# Potential Steering Hardline Contact with Engine Oil Cooler

**Product:** Reelmaster® 5010 Series

**April 20, 2017**

**Figure 1**

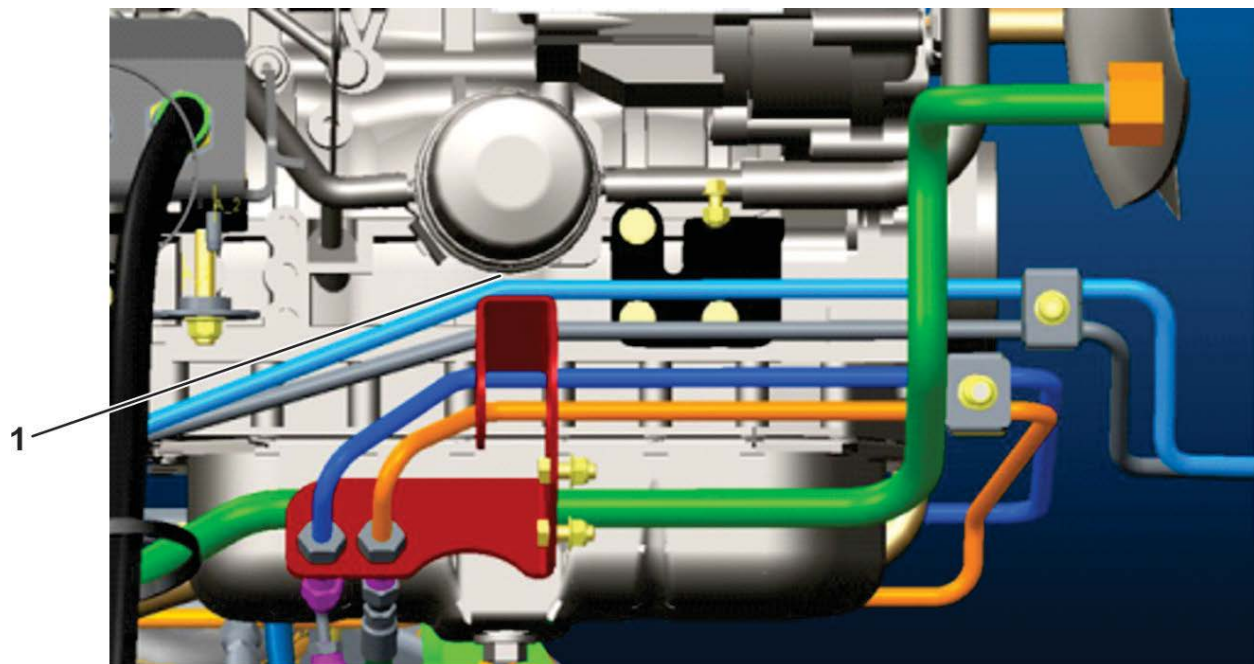
A steering hard line could contact the bottom of the engine oil cooler. If this contact continues, over time the steering hard line will wear and may ultimately fail.

1. Area to check for adequate clearance ( $\frac{1}{4}$ " or 6 mm) between hard line and cooler.

During maintenance, inspect the area near the engine oil filter/cooler to ensure there is ample clearance between the cooler and the steering hard line. If the hard line is contacting the engine oil cooler, bend the line down, away from the cooler until it clears. Inspect the hard line for any damage that could result in failure.
